Appl. No. 10/807,524
Amdt. dated Aug. 18, 2005
Reply to Office Action of May 18, 2005

Amendments to the Drawings:

REMARKS/ARGUMENTS

Appl. No. 10/807,524
 Amdt. dated Aug. 18, 2005
 Reply to Office Action of May 18, 2005
 Annotated Sheet Showing Changes

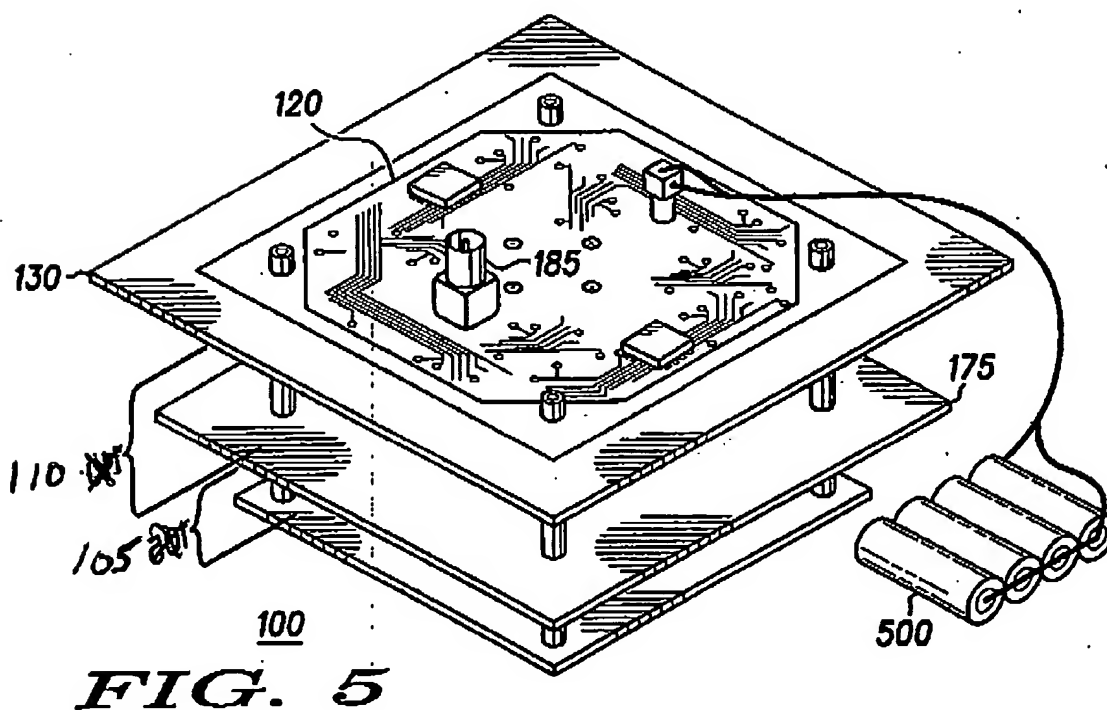
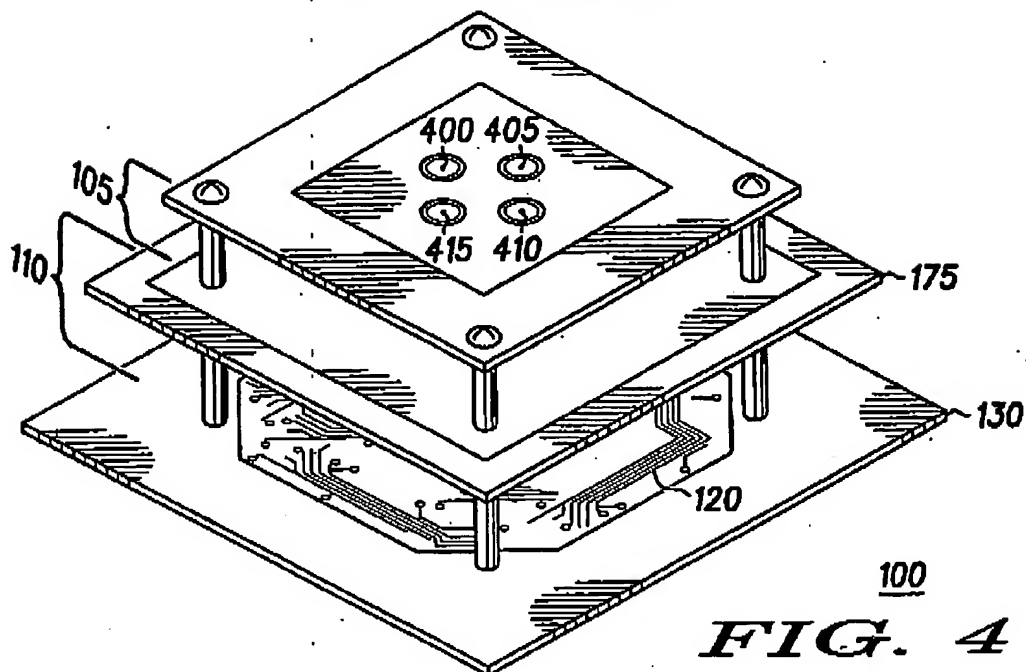
The attached sheet of drawings includes changes to FIG. 5. This sheet, which includes FIGs. 4 and 5, replaces the original sheet including FIGs. 4 and 5. In FIG. 5, the orientation of reference numerals "105" and "110" have been corrected such that they are readable from left to right.

5. Applicants have amended FIG. 5 of the drawings to correct the orientation of reference numerals "105" and "110" such that they are readable from left to right. Applicants submit that all such drawing amendments are fully supported by Applicants' originally filed specification and, therefore, do not introduce any new matter into the specification.
